12 JUNE 2023 230612 NPC-JC Consultation Response [R3.0138-21]

STATEMENT OF OBJECTION – PLANNING APPLICATION [R3.0138/21]. HIF1 Road between A34 Milton Interchange & B4015 north of Clifton Hampden <u>REVIEW OF THE ENVIRONMENTAL STATEMENT - DATED APRIL 2023</u>

Figure 1 plan illustration of alternative position (in red) for HIF1 road and bridge crossing Appleford rail sidings.

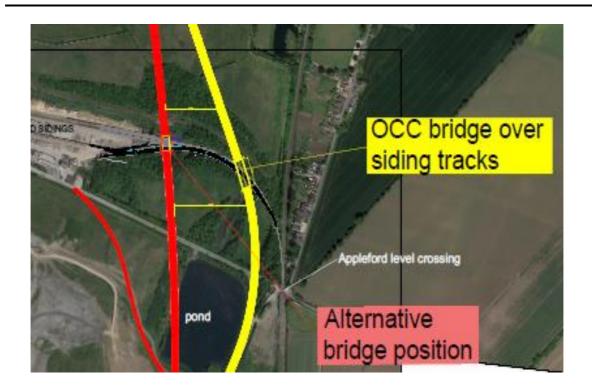
- 6.8 The planning team of the Vale of White Horse DC state that due to the fact that "residents of affected dwellings will experience significant adverse effects despite acoustic barriers" and "the visually intrusive appearance of the acoustic barriers, consideration should be given to moving the road further west."

- 6.9 A viable alternative road alignment further west, for the road and bridge over Appleford Sidings is available, see figure 1. This alignment would nor require a skewed bridge design which would result in a more efficient smaller bridge structure. The road's further distance away from dwellings in Appleford would reduce the noise impact and provide the offset distance for other landscape-based noise attenuation. A comparison of noise environment of both alignments need to be undertaken to allow a selection of the route alignment that minimises the noise impact on nearby dwellings.

- 1. The existing bridge proposal must be refused as Paragraph 134 of the NPPF.
- 2. No planning approval for the HIF1 scheme can be granted until a further analysis is undertaken on road and bridge alignment as part of a consultation exercise with affected residents.
